Title: LIGHTING FIXTURE FRAME AND MOUNTING PANEL APPARATUS  
 Filed: 7-31-2003 Inventor: Shin W. Rhee  
 Practitioner's Docket No.: THINL.64349

ANNOTATED SHEET SHOWING CHANGES

### **AMENDMENTS TO THE DRAWINGS:**

FIG. 11

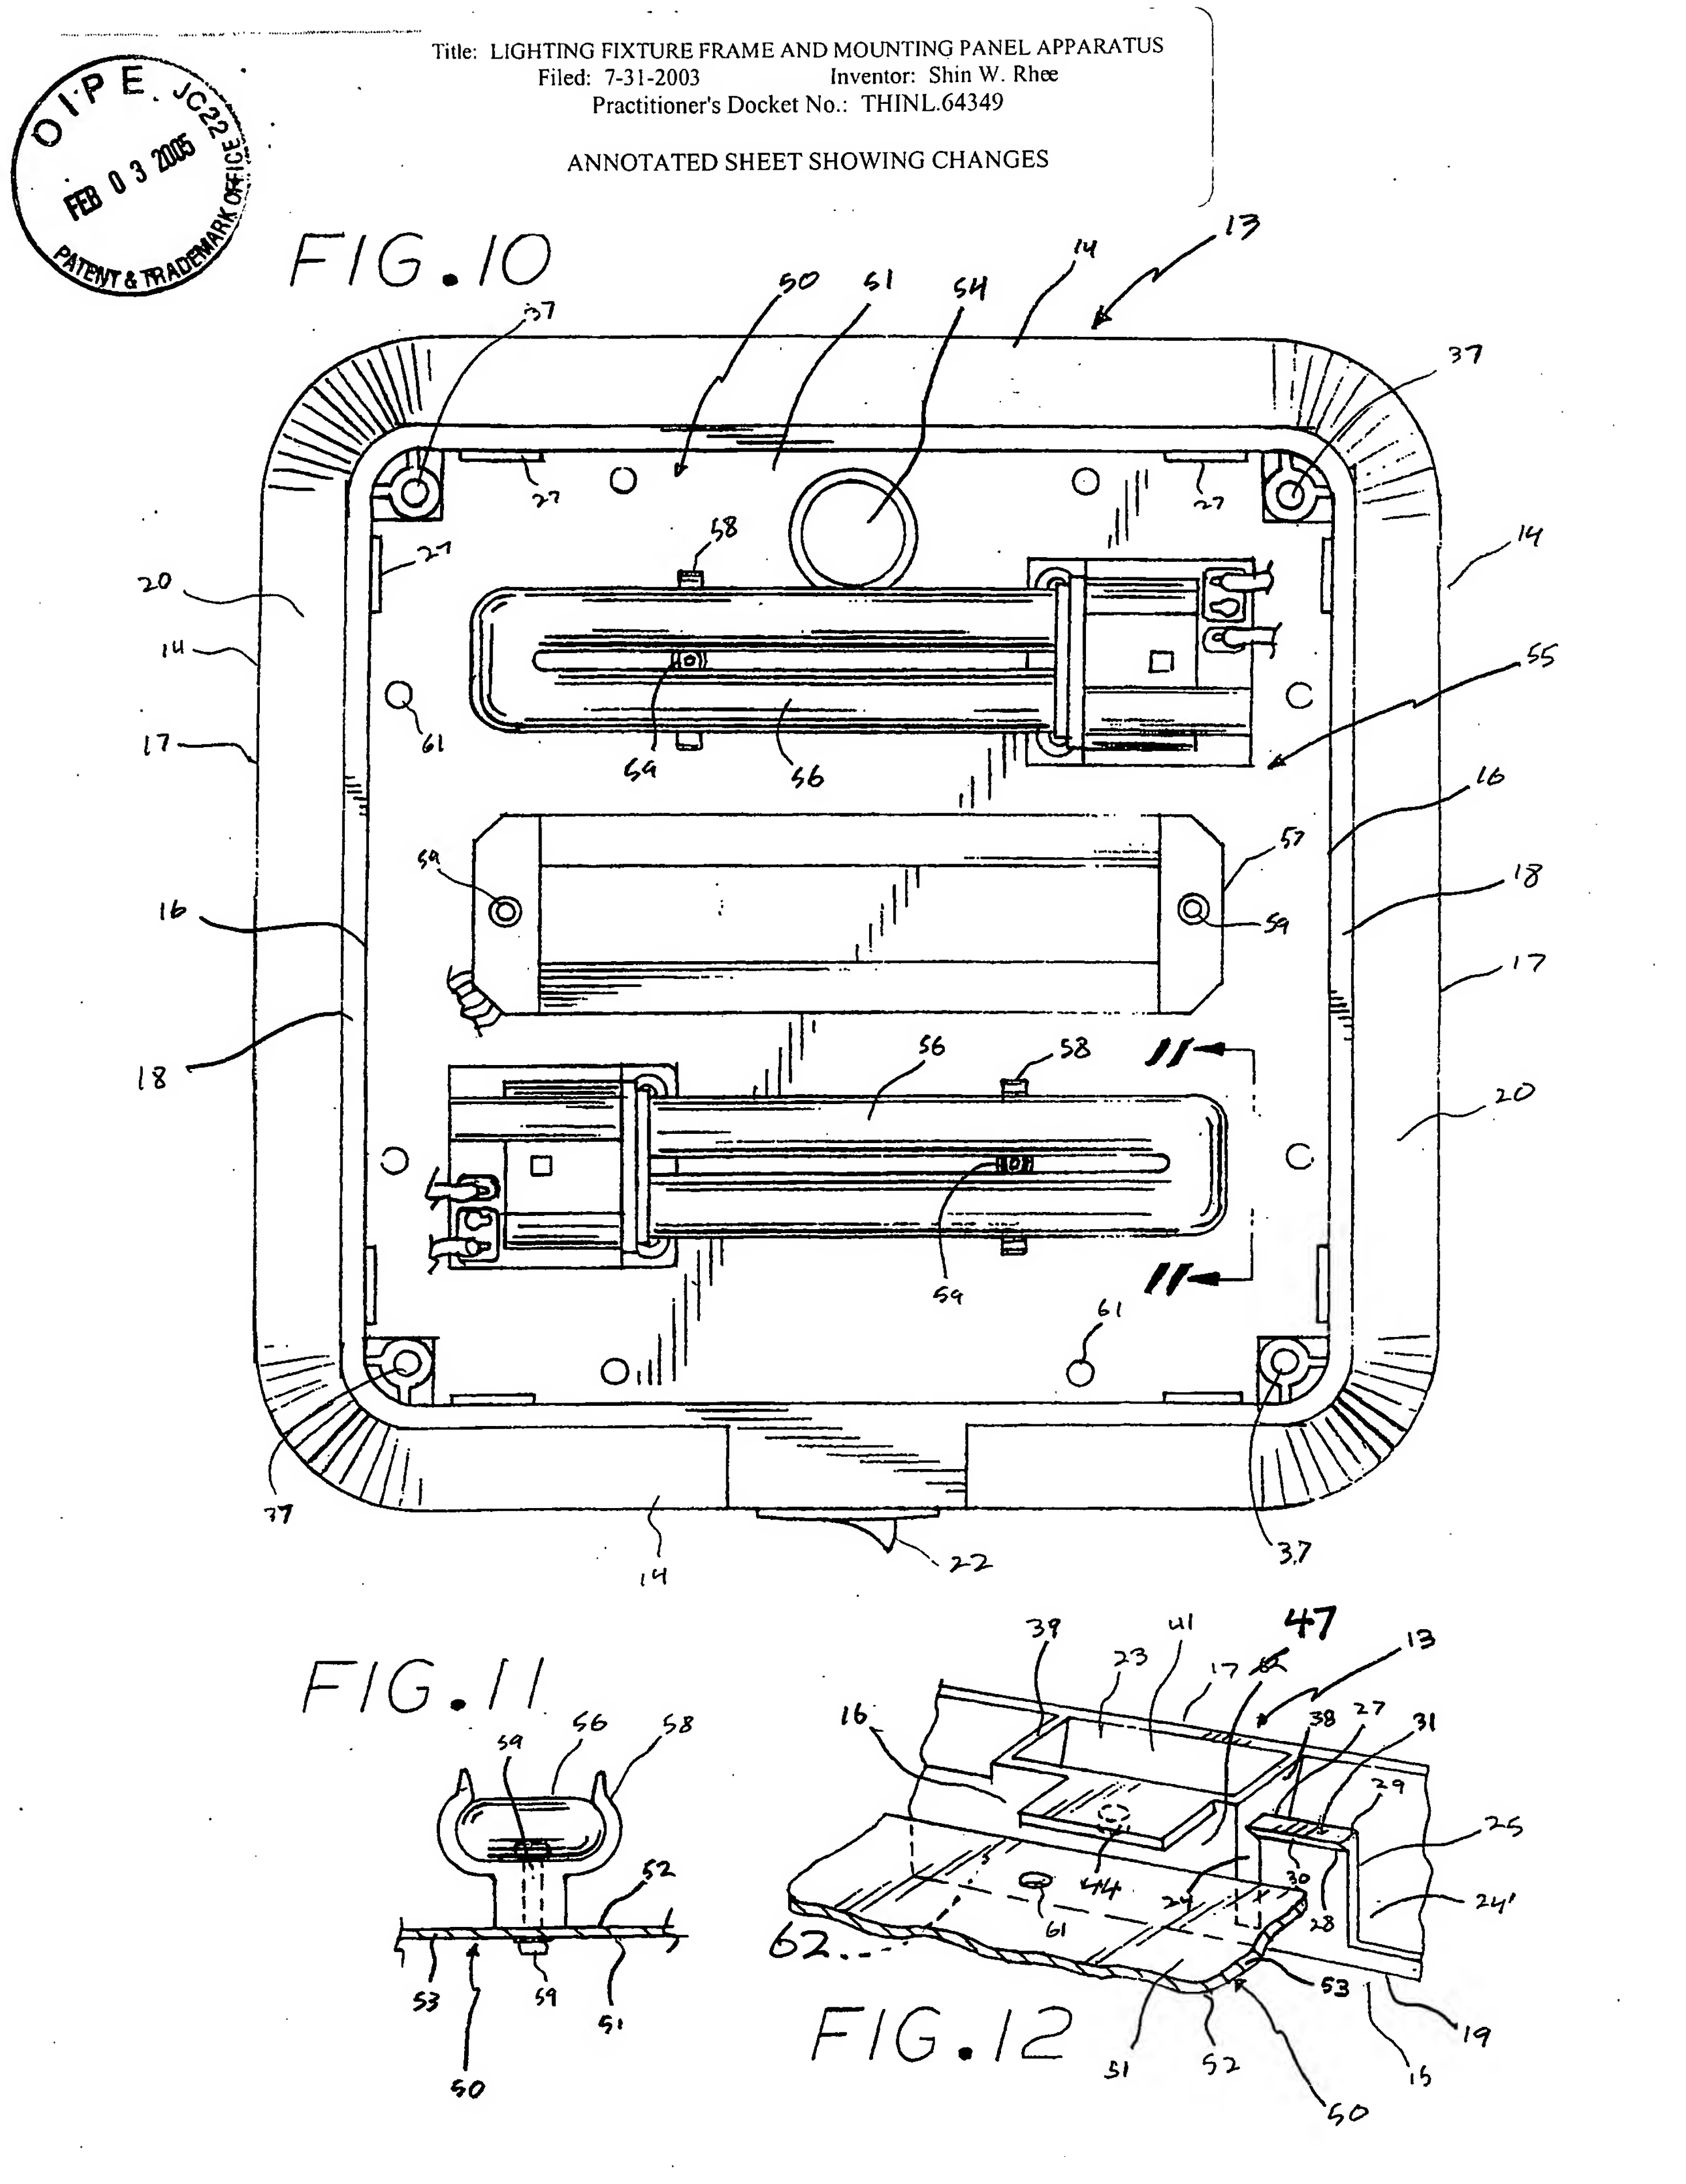
In the subject Office Action, the Examiner has also objected to the drawings. Specifically, the Examiner's detailed review of Applicant's drawings revealed that they failed to include reference element number 47, as referred to in the written description, and also failed to show a reference element number for certain features recited in the claims.

In the formal drawings which Applicant has filed concurrently herewith, and in the Replacement Sheet and Annotated Sheet Showing Changes included as an exhibit to this document, Applicant has correctly depicted reference element number 47 in Figure 12 of Sheet 4 of 4. Also, reference element number 62 has been redrawn. Consideration of these revisions should remove this objection.

The attached replacement sheet of drawings (sheet 4 of 4 as originally filed) includes changes to Fig. 12. This sheet, which includes Figs. 10-12, replaces the original sheet including Figs. 10-12. In Fig. 12, previously mislabeled element 62 has been changed to element number 47, and a new depiction of element number 62 has been added.
